ADDENDUM NO. 6

RE: Furniture for the New City of Grand Junction Community Recreation Center, RFP-

5748-25-KF

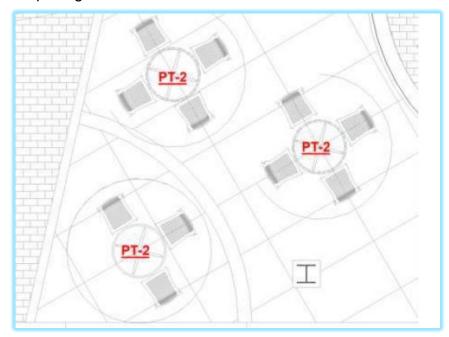
19. **Question:** Regarding the Addendum 5 pricing spreadsheet.

PT-2 should be 2 tables with 4 attached chairs and 1 table with 3 attached chairs (ADA), based on this image; however, the response spreadsheet lists "qty. 3 patio tables w/attached chairs.

It might make more sense to list these as

PT-2 Quantity 2

PT-2 ADA Quantity 1

Response: The City appreciates the clarification and your attention to accessibility requirements. At this time, the format and structure of the Addendum 5 Revised Attachment A – Furniture RFP Response Spreadsheet will remain unchanged. All proposers must use the provided spreadsheet as issued.

To account for the pricing of the ADA-compliant table, please use the "Size" or "Notes" column to clearly identify and distinguish the ADA unit and its associated pricing. This will ensure consistency across submissions while allowing for accessible options to be appropriately considered.
